FINAL DRAINAGE PLAN AND REPORT

16140 OLD DENVER ROAD

PCD File No. PPR-16-037

SUBJECT: Drainage Plan and Report
All About Outdoor Storage PPR-16-037

Detention Basin Outlet Structure Design

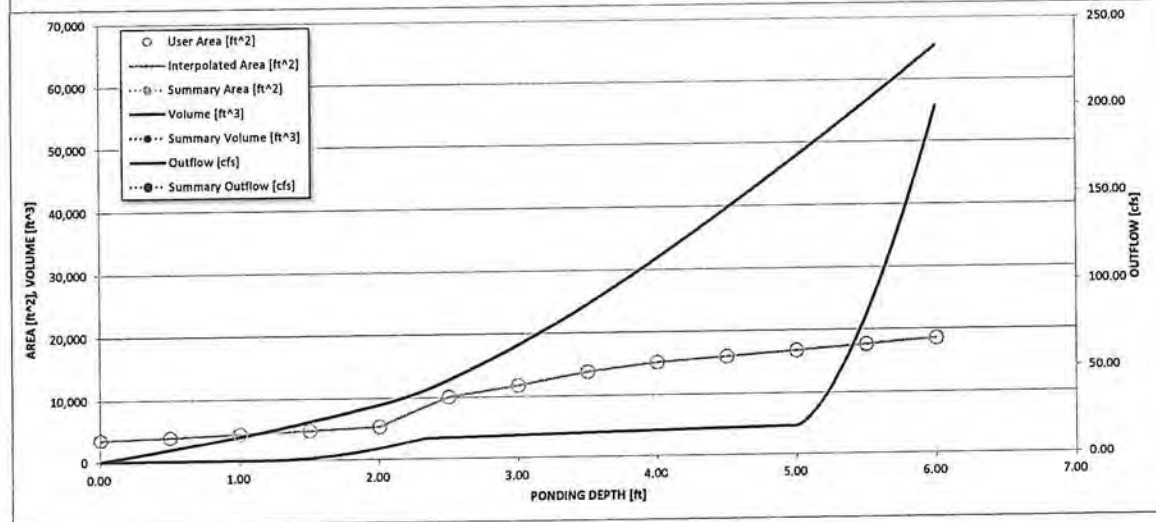
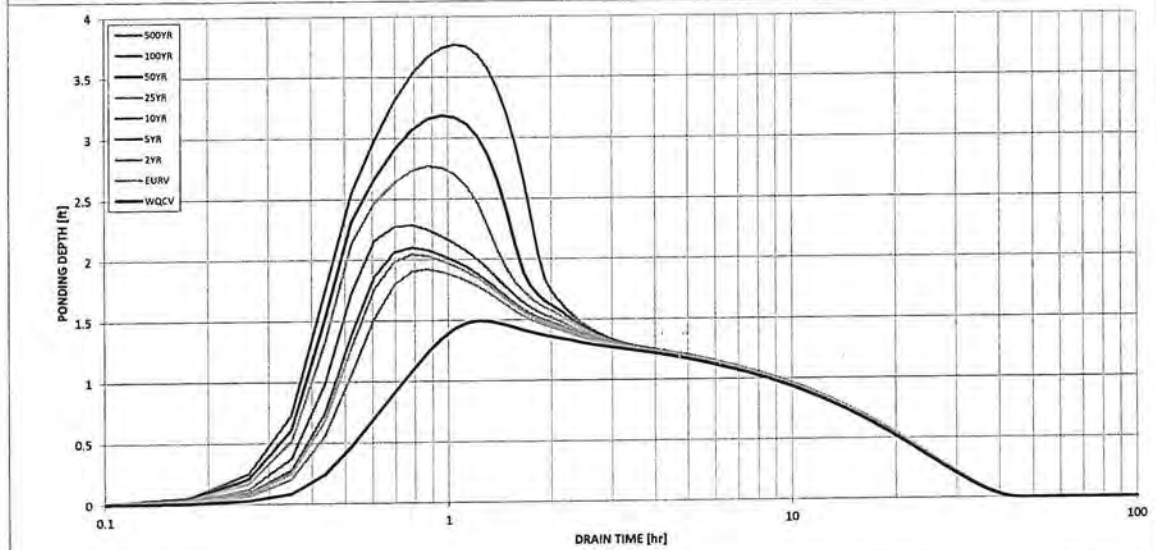
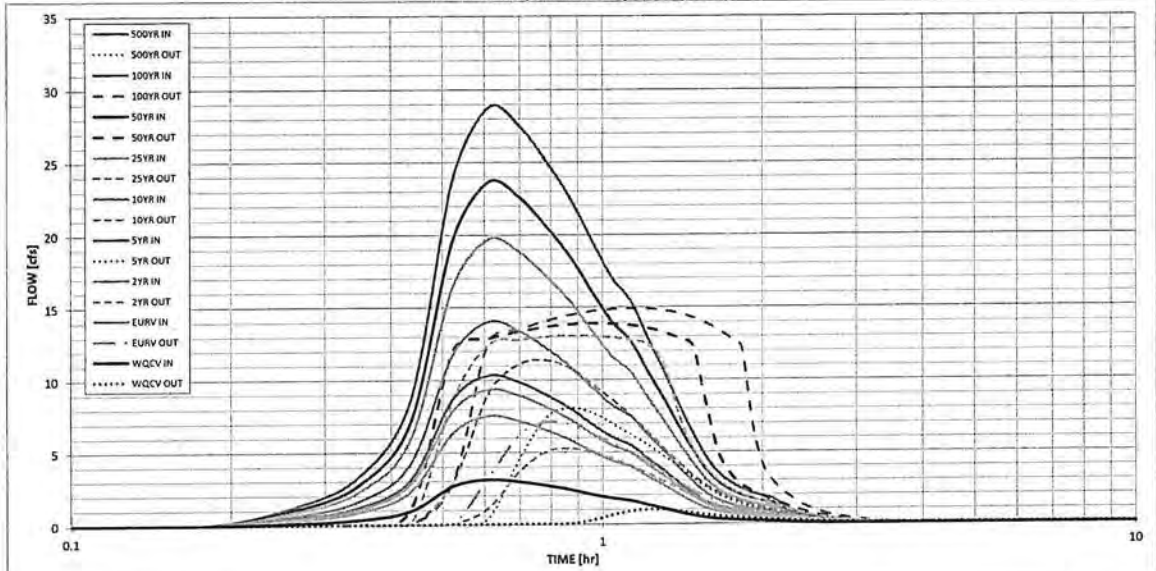
Revise to Weir & Pipe (Restrict) to match the plans.

Revise to 4.25 per plans. This may resolve the comment below regarding the ratio of peak outflow to predevelopment Q

Revise outlet design so the values are equal to or less than 1.0. Peak outflow must be equal to or less than predevelopment flow.
